City of Ramsey
Agenda
Regular Planning Commission
Thursday, January 23, 2025
7:00 pm
Council Chambers, 7550 Sunwood Drive NW

PUBLIC HEARING: Consider a Preliminary Plat and Variance Request for Riverstone South 6th Addition (Project No. 24-127); Case of Development Consulting Services, LLC

PUBLIC HEARING: Northstar Truck & RV Parking - Rezoning and Site Plan Review - 15861 Jarvis St. NW

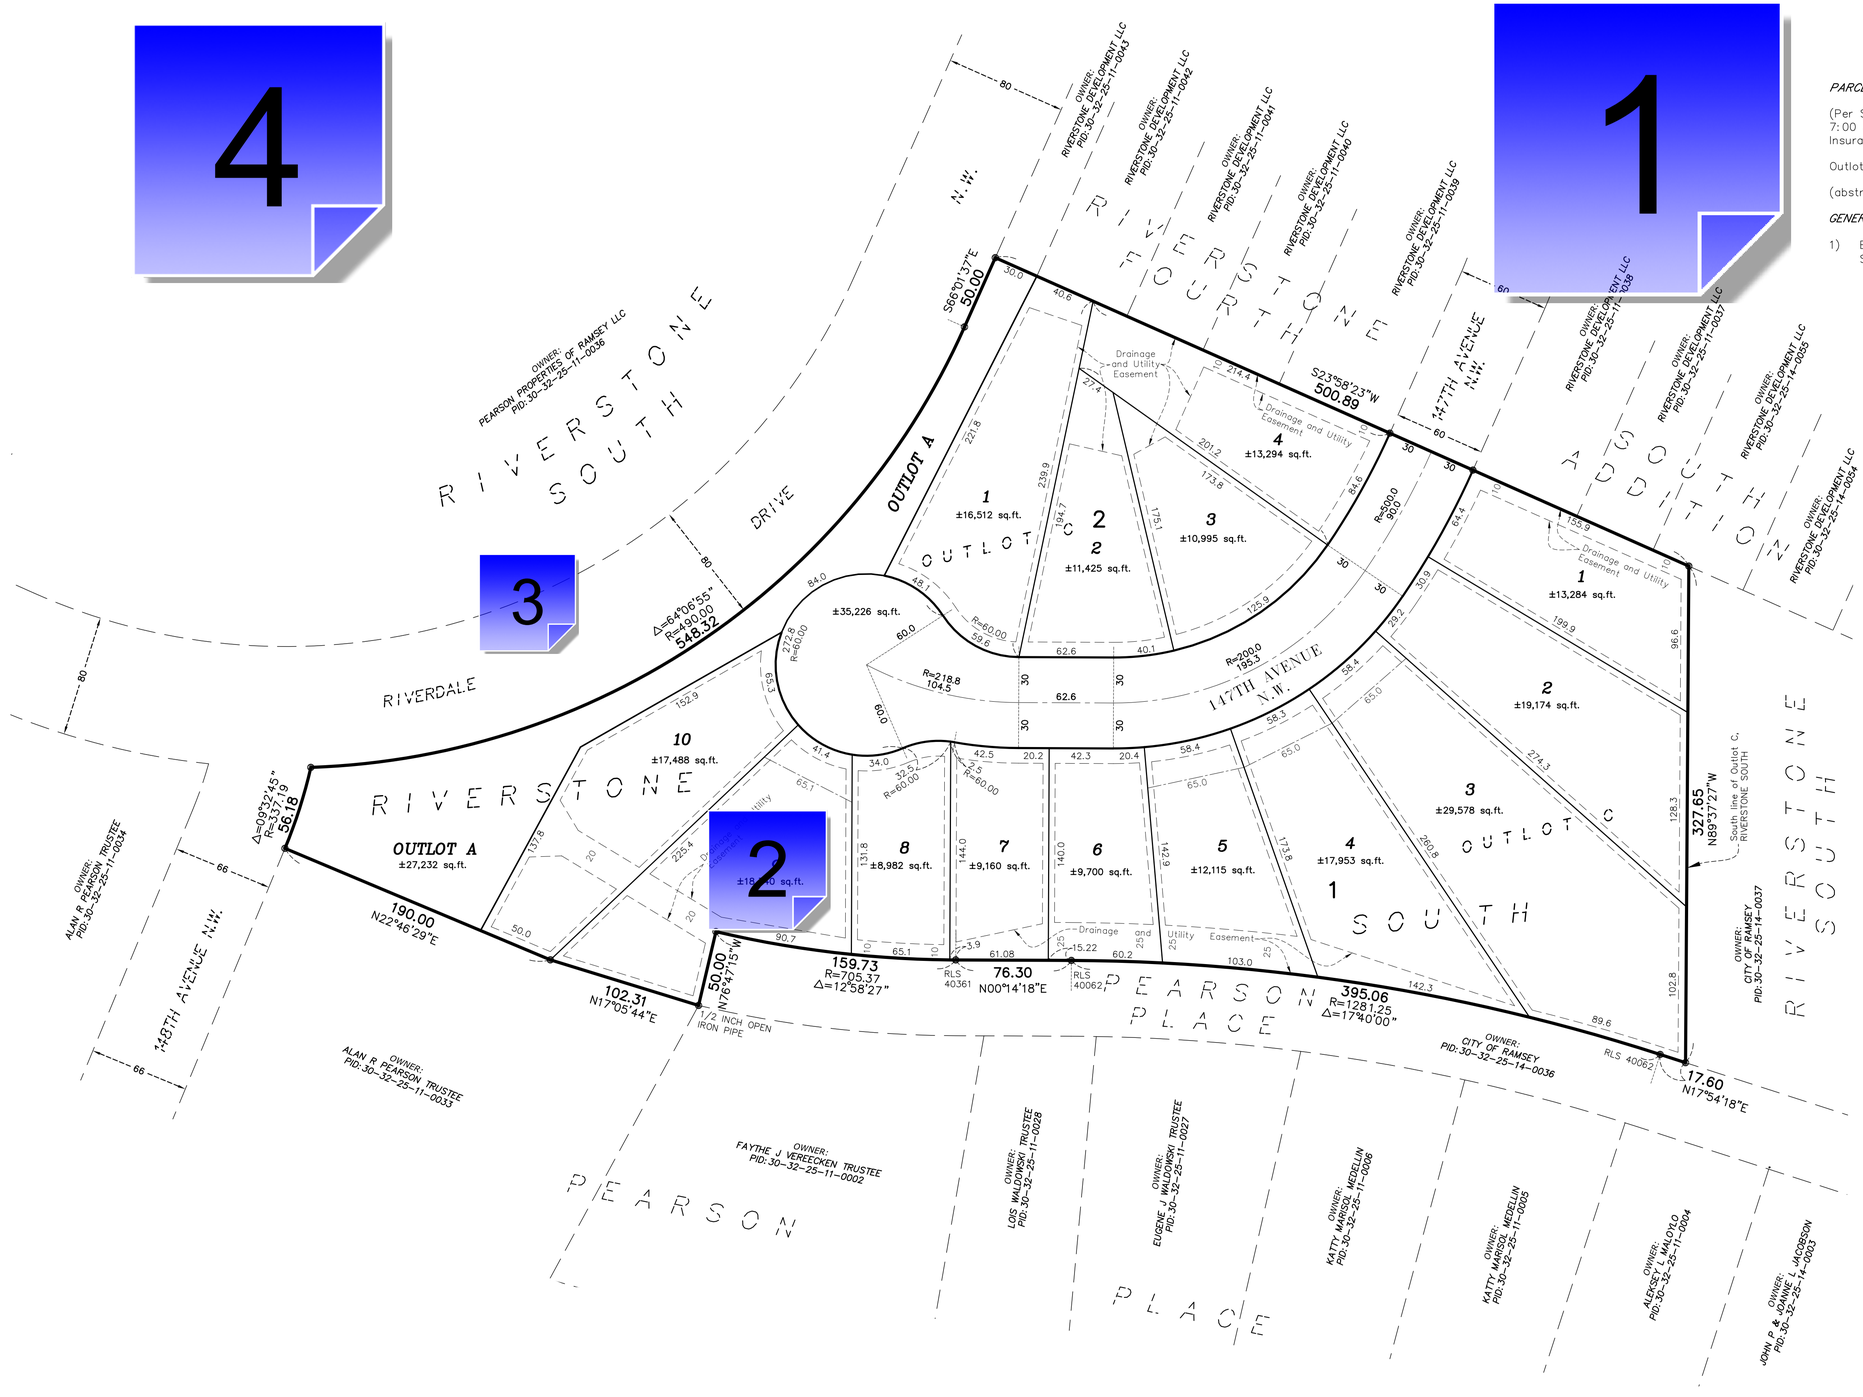
On the city's 50-foot wide corridor, will there be enough sunlight for this seed mix to establish?

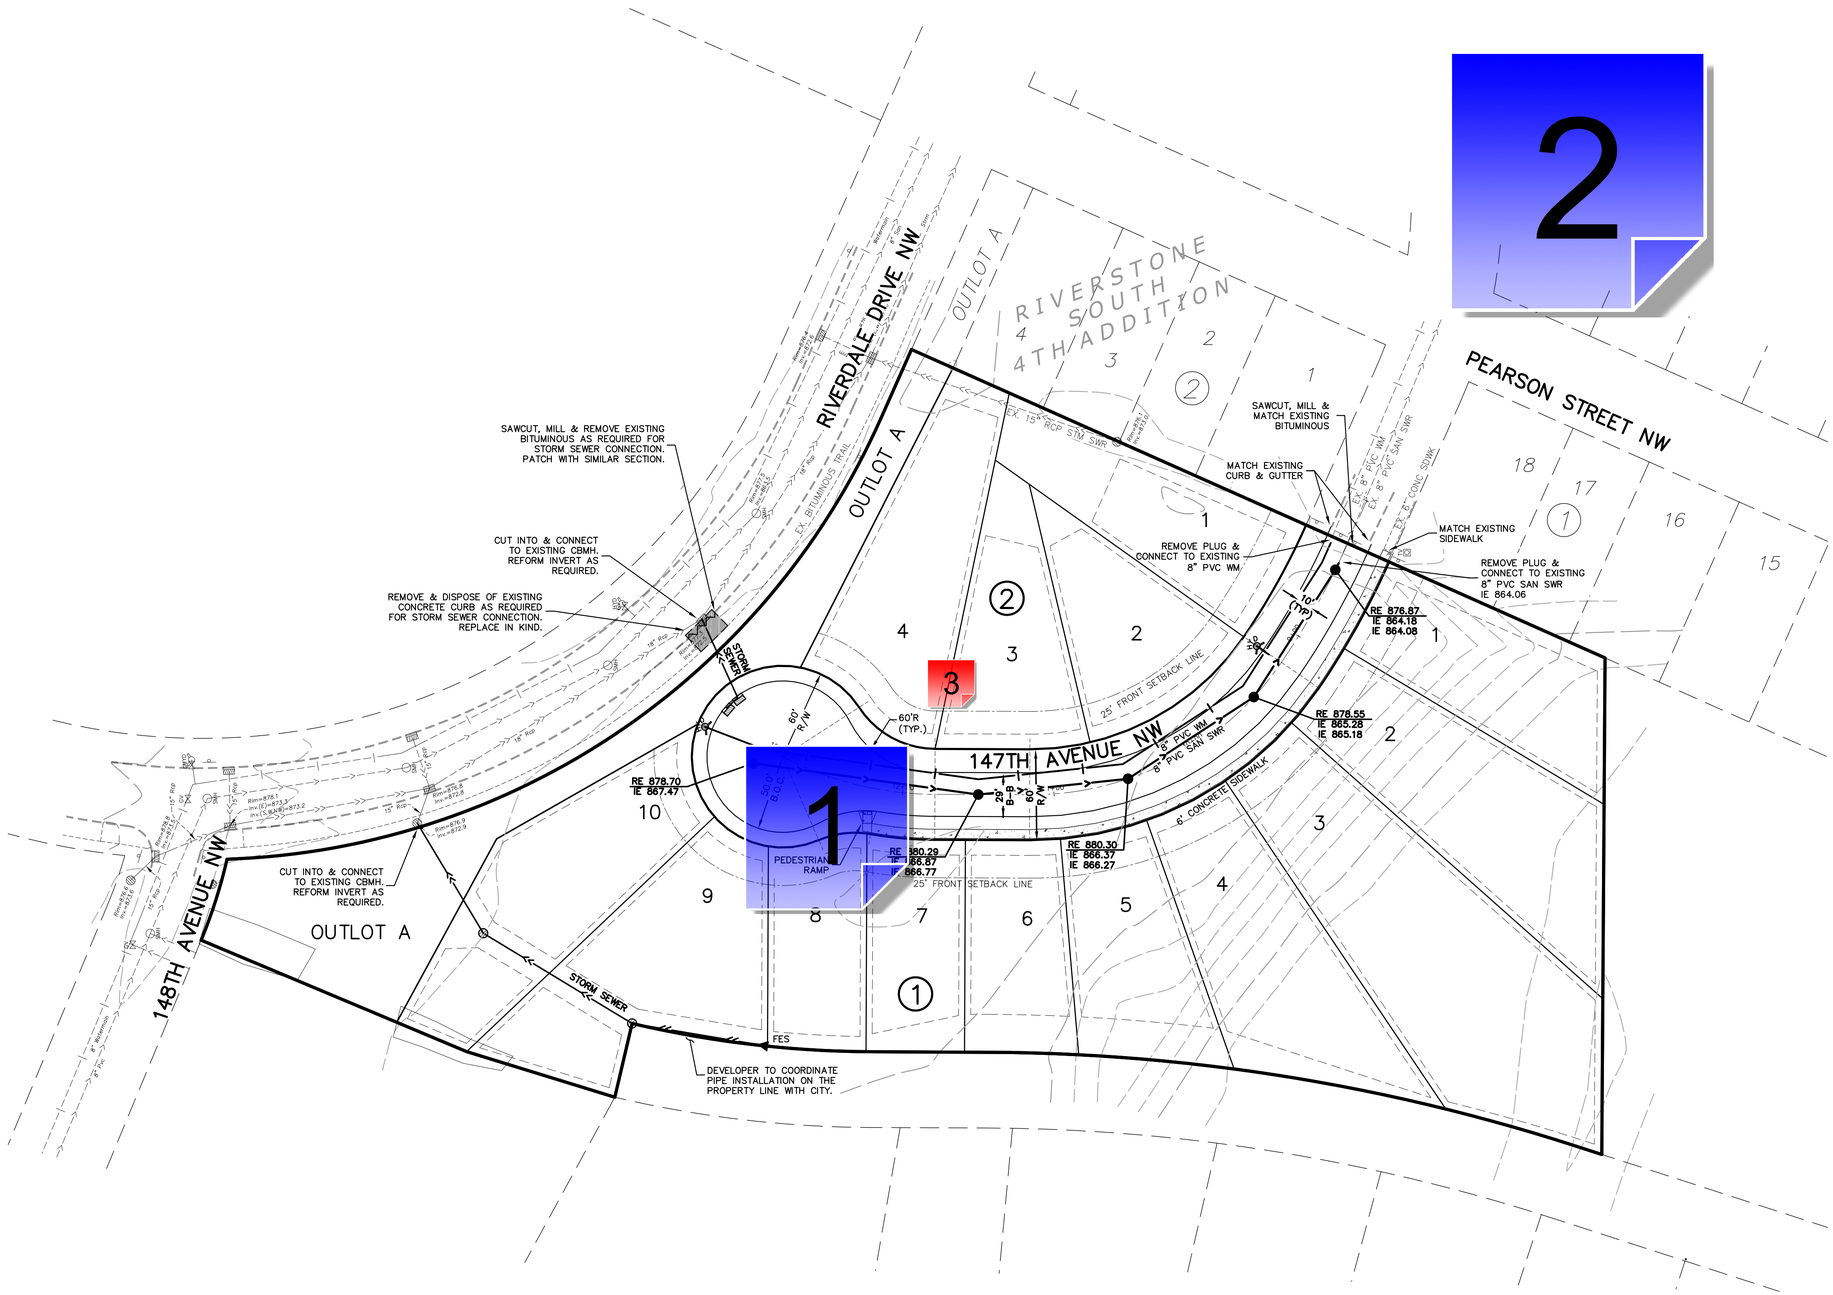
Please add the lot width, measured at the minimum front yard setback of 25 feet, for Lots 1-10, Block 1. Each lot must be at least 65 feet wide at the minimum required front setback.

All homes constructed will need to meet the minimum front yard setback of 25 feet and cannot be setback more than 35 feet from the front lot line.

Surveys for each building permit will need to include the total proposed impervious coverage for each lot. Impervious coverage is limited to a maximum of 40%, and since this is within the Mississippi River Corridor Critical Area (MRCCA), it is necessary to verify compliance with this standard.
